## Supplementary Information – Public Information Package Report

### Proposed Maintenance Dredging at the Port of Hay Point

This **'Supplementary Information – Public Information Package Report'** provides NQBP's responses to this additional information request.

**Response to GBRMPA's peer review of the  
dredge plume modelling**

Figure 1: Model domain (white box) along with measured wave data sites (yellow pins).

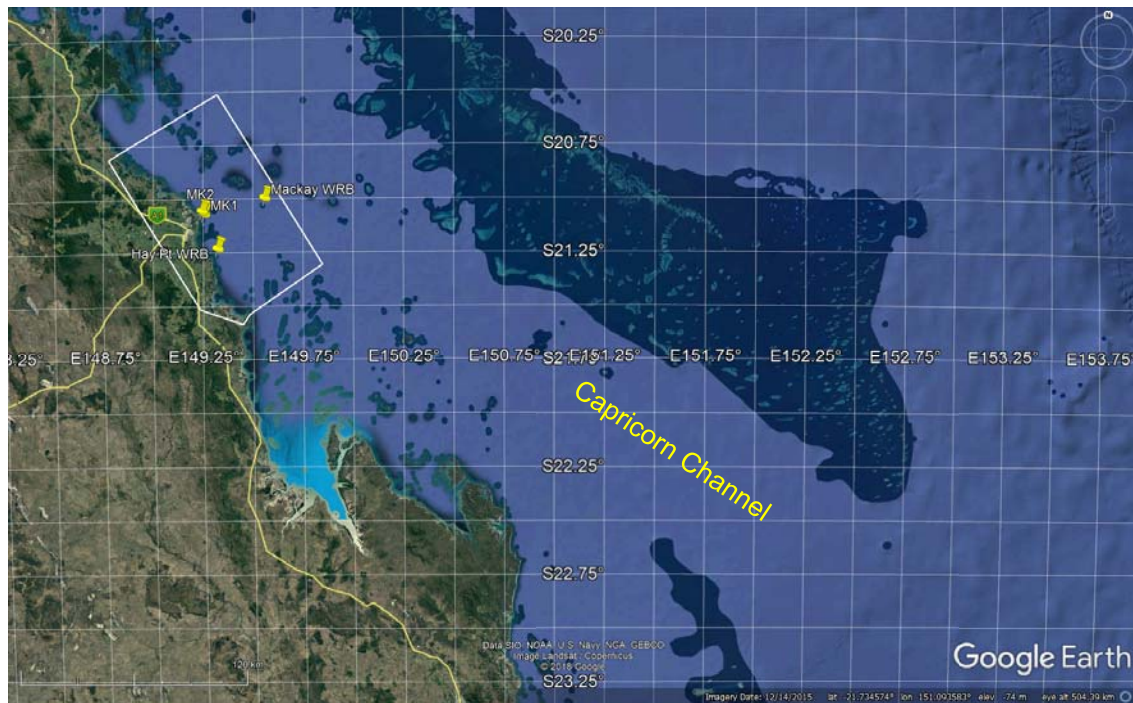
P10 & Fig 8 P13: these do use coastal stations to influence the estimation of altimeter derived geostrophic currents. It is very much tide and wind dominated in the shallow coastal region. The Coral Sea circulation is more about the SEC forming the EAC along the outer GBR that can also drive a lagoonal branch along the lagoon inside of the outer reef matrix (Brinkman et al 2006)	Comment noted.
P14: Characterisation of east to west movement of cyclones is typical e.g. TC Hamish and many other tracks	Agree that this is typically the case.

The model domain is shown in Figure 1 along with the locations of the measured wave data (including the Mackay wave rider buoy (WRB)) and the Capricorn Channel. The plot shows that the Mackay WRB is located approximately mid-way along the eastern boundary of the wave model. In addition, based on the wave exposure to the south-east (from Capricorn Channel), and given that the depth along the southern half of the eastern boundary of the wave model is similar (approximately 35 to 40m below LAT), it seems reasonable to assume that the wave conditions measured at the Mackay WRB would be approximately representative of the wave conditions along the eastern boundary down to the southern boundary.

Figure 2: Measured currents around low tide slack water 03/05/2012 15:00 (Site 4).

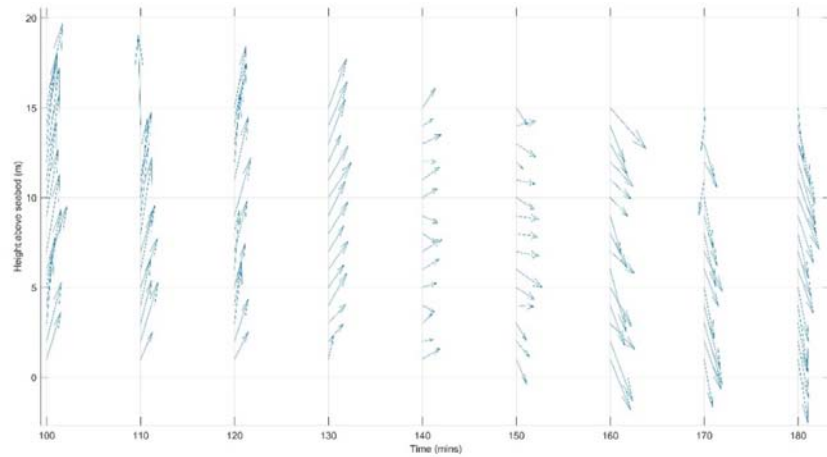
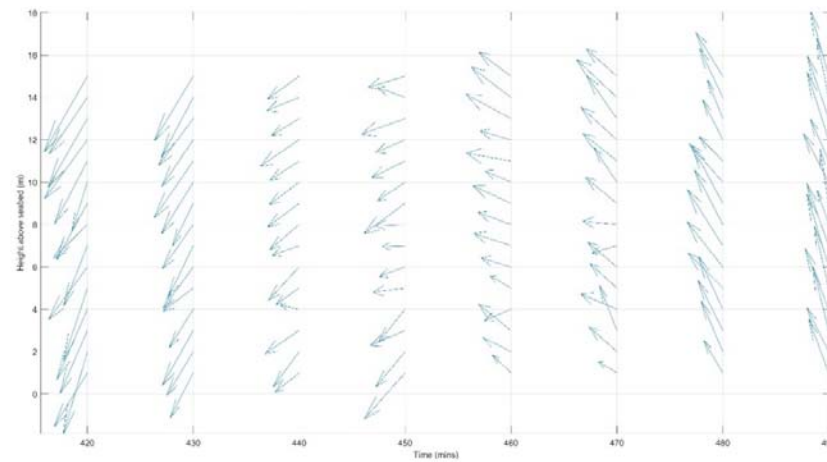
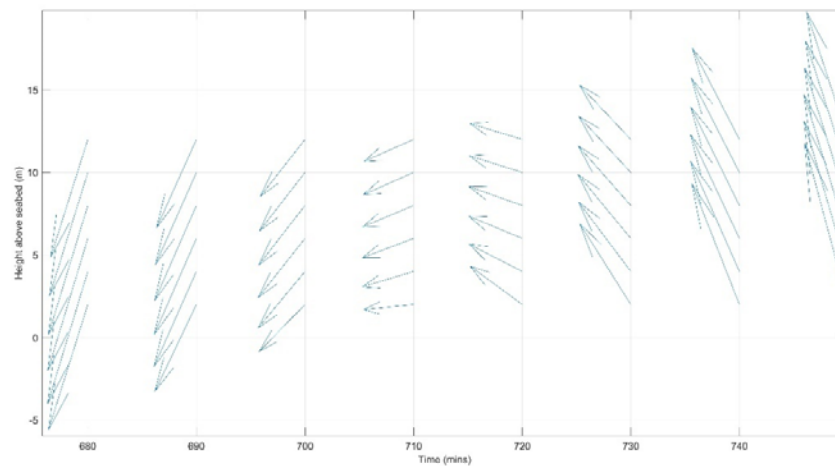
S4.3.2 Figures 32-40 shows near bed, mid and near surface observations vs model however all others throughout the report are mid column or depth averaged. Figures 32-40 do not provide a clear indication of vertical shear and the existence of any bottom boundary layer at the timescales	Based on the measured data the currents in the Hay Point region appear to be relatively uniform (with speeds higher near the surface and lower near the bed), with currents throughout the water column rotating together as the tide changes. This

The measured tidal currents at ADCP Site 4, (located adjacent to the previous dredge material placement site, at a depth of approximately 15m below LAT), are shown during a spring tide through the water column and over time at the turning of the tide at low water (Figure 2) and at high water (Figure 3). The plots show that as the tide turns the current direction changes throughout the water column, with similar changes in direction occurring at all depths and no indication of flow reversals occurring. As a comparison, the modelled currents through the water column are shown in Figure 4 during the same spring tide around high water<sup>1</sup>. The plot shows that the modelled current directions are almost identical through the water column as the tide turns and they also correspond well to the directional changes shown by the measured data in Figure 3.

Figure 5a: 95<sup>th</sup> percentile SSC, Bed layer

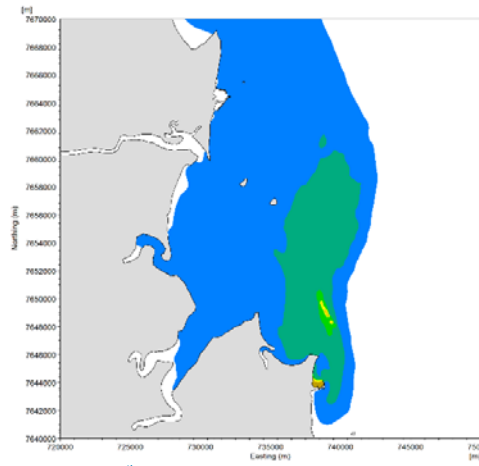
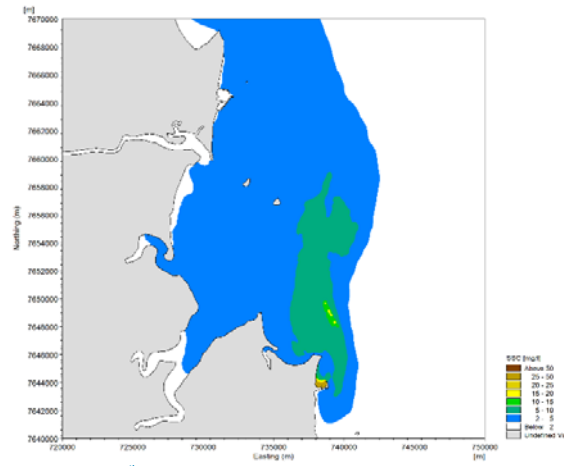
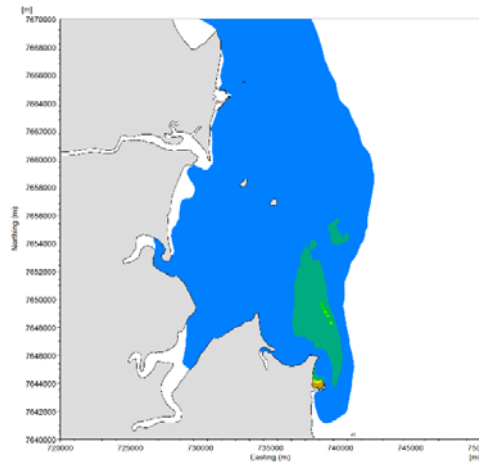
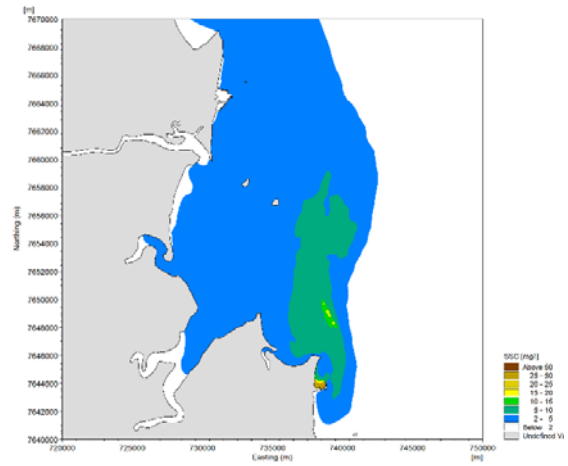
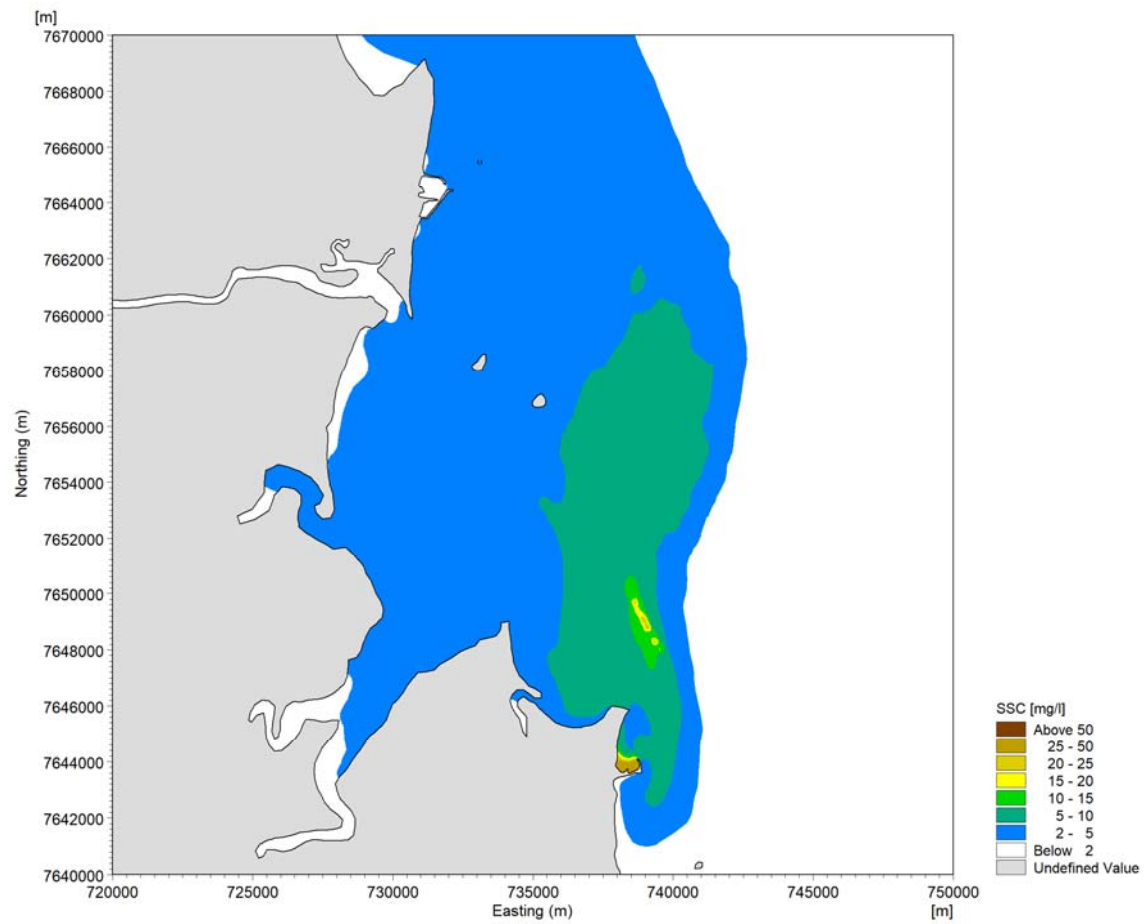
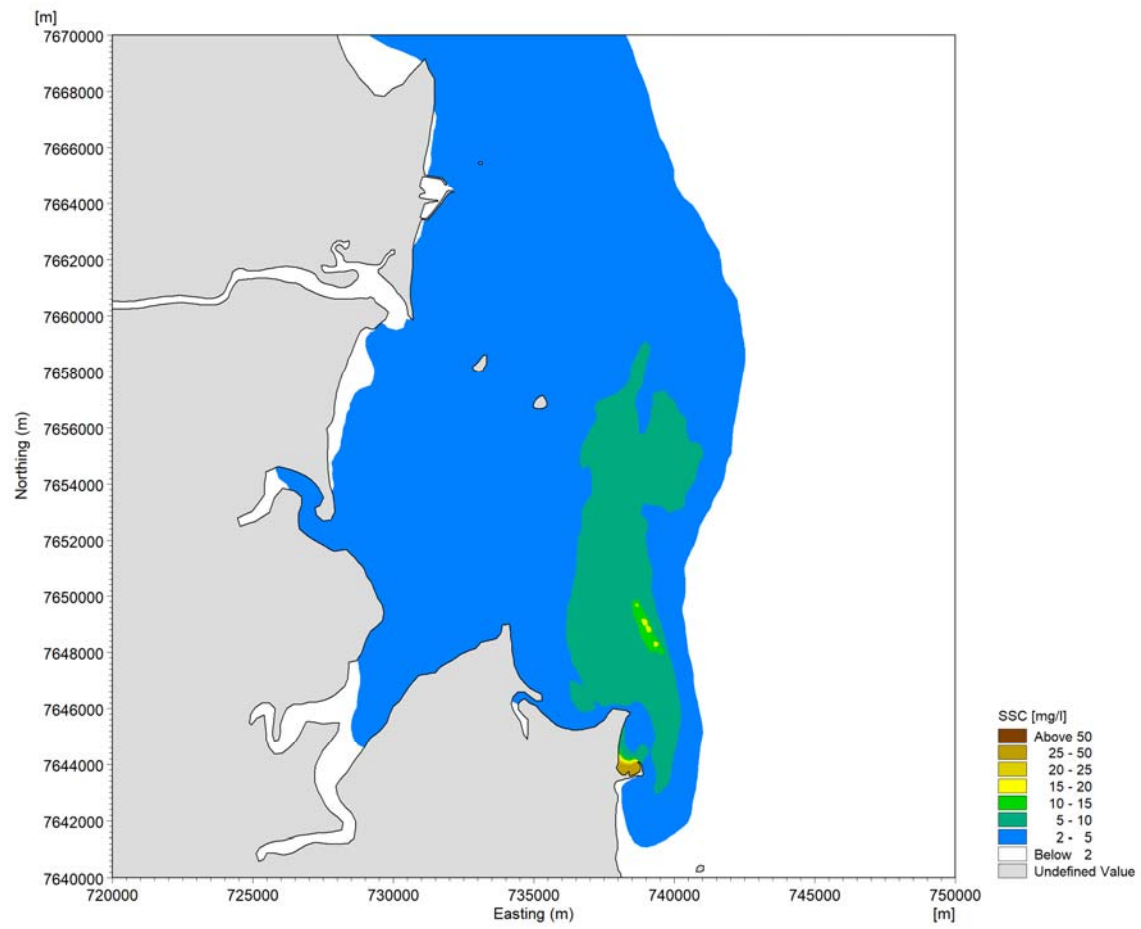
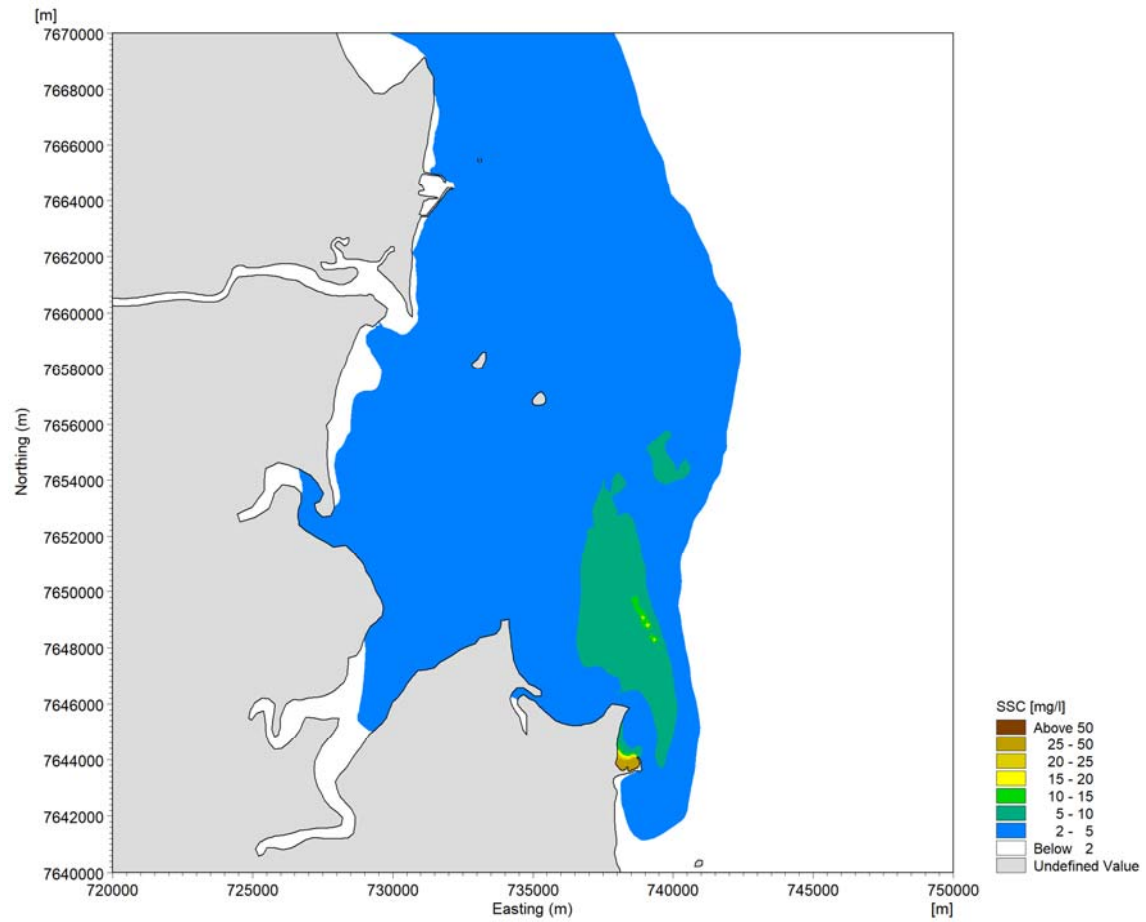
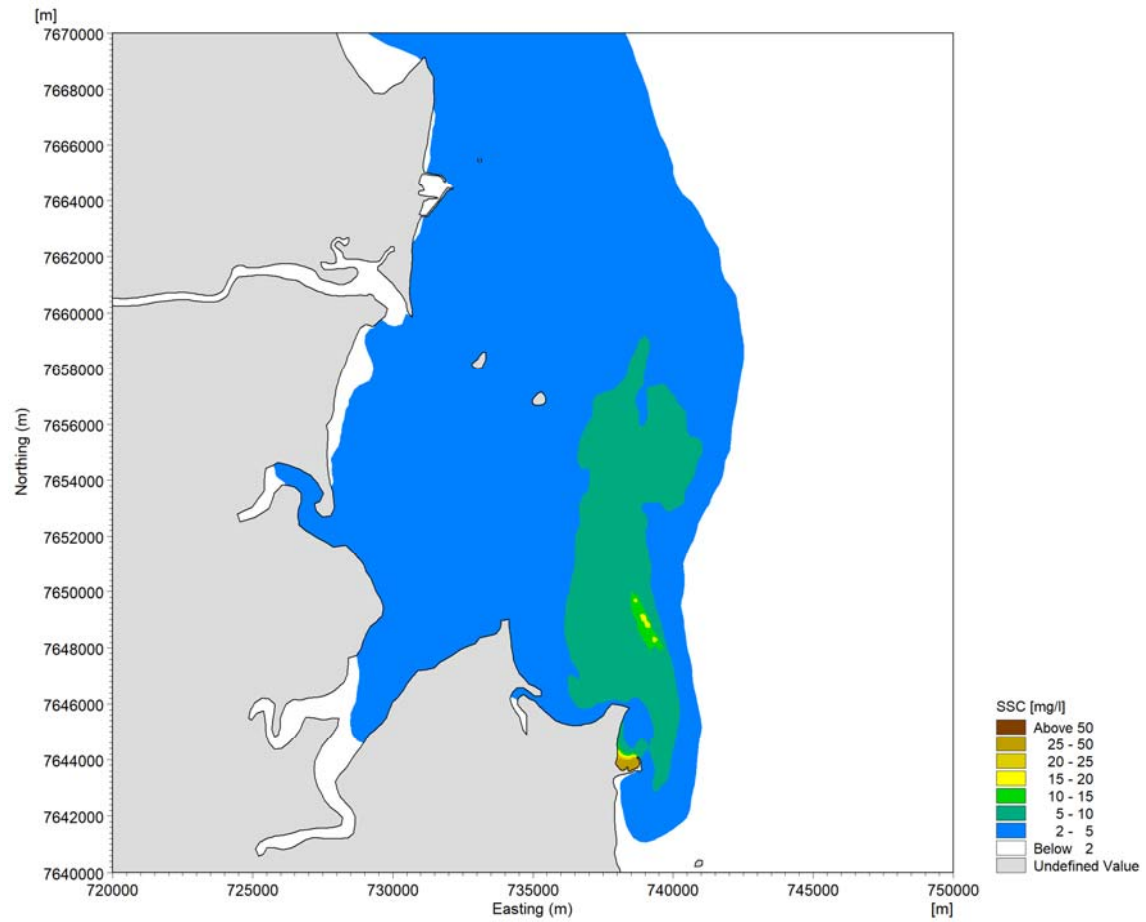
The comment P96 S7.1: “As all of the natural SSC simulations were undertaken in two dimensional depth averaged mode, all of the dredging runs are presented as depth averaged to ensure they are directly comparable to the natural conditions.” Assumes that SSC is uniform through the water column. This assumption needs rigorous validation.

The 95<sup>th</sup> percentile SSC for a dredge scenario (400,000 m<sup>3</sup> in the wet season) is shown for the bed layer, middle layer, surface layer and depth averaged over the five layers as a summary in Figure 5, and individually in Figures 6 to 9. The plots show that there is a difference in SSC between the different layers of the water column, with higher SSC at the bed and lower SSC at the surface, but also that the same spatial pattern in SSC occurs in all the layers. Comparison between the 95<sup>th</sup> percentile based on the depth averaged SSC and based on the middle layer of the model show very similar results.

Figure 10a: 95<sup>th</sup> percentile SSC calculated assumed the dredged sediment is released uniformly through the water column

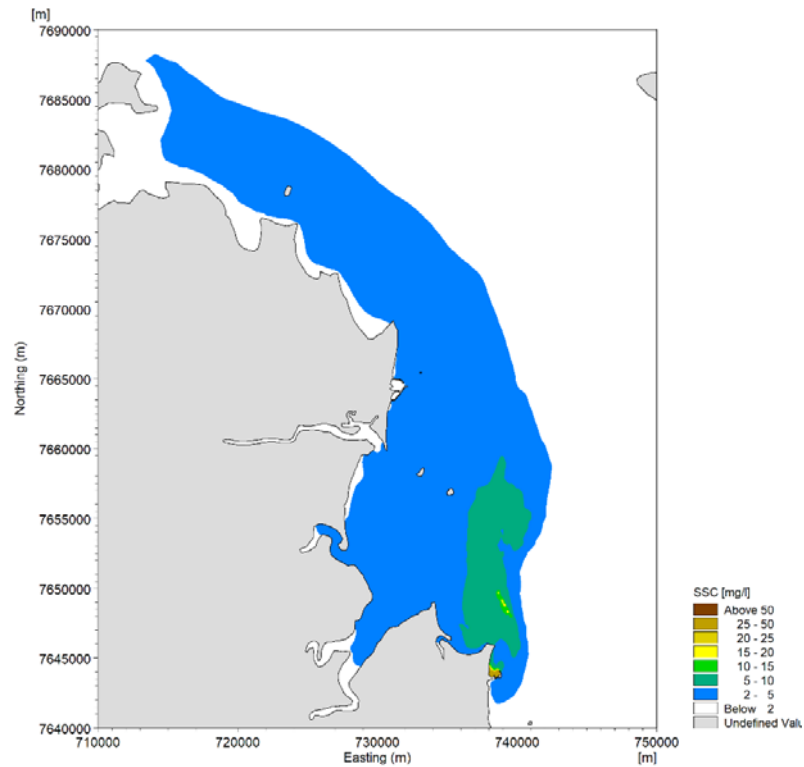
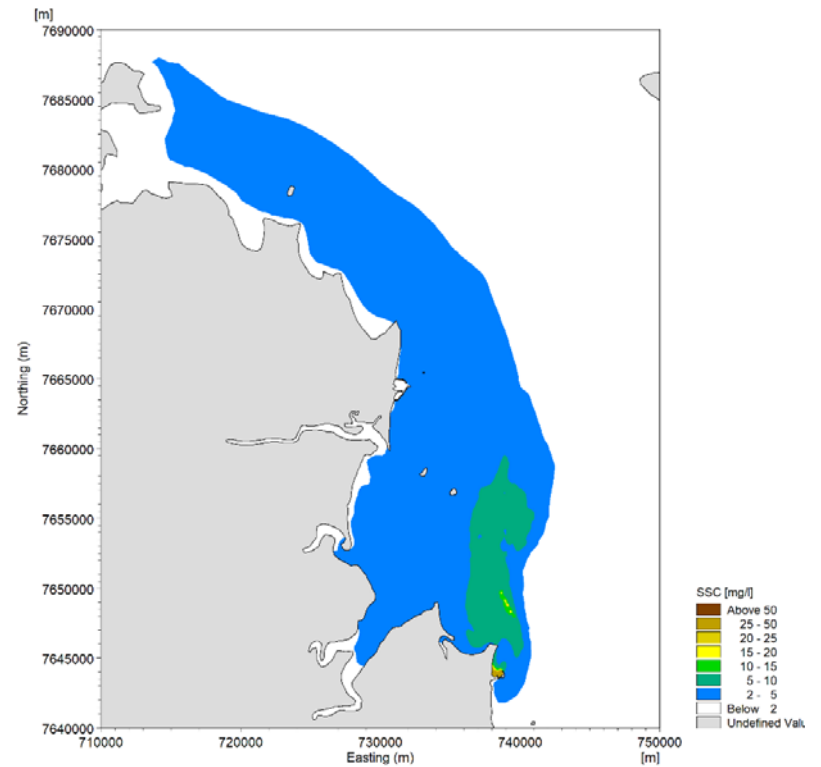
Specific Comments	NQBP Response
P89 S5.3: PSD acronym needs defining – only apparent in Fig67	
P93: Results of water column effect of dispersion and advection suggested no different from a uniform release throughout the water column – but no evidence provided	
P96 S7.1: “As all of the natural SSC simulations were undertaken in two dimensional depth averaged mode, all of the dredging runs are presented as depth averaged to ensure they are directly comparable to the natural conditions

Figures 10a and 10b show how the 95<sup>th</sup> percentile SSC, (this was selected over the median as it provides more information to compare), varies when the sediment released from the dredging is assumed to be released uniformly through the water column (Figure 10a), when it is released near the bed (drag head and propeller wash) and mid water column (overflow and material placement) (Figure 10b). Although there are some small differences between the results, the plots give confidence that the assumption regarding the location of the release in the water column does not influence the final results. This is likely to be due to the uniformity of the currents through the water column and the relatively high tidal current speeds, meaning the plume would be advected and dispersed through the water column quickly.
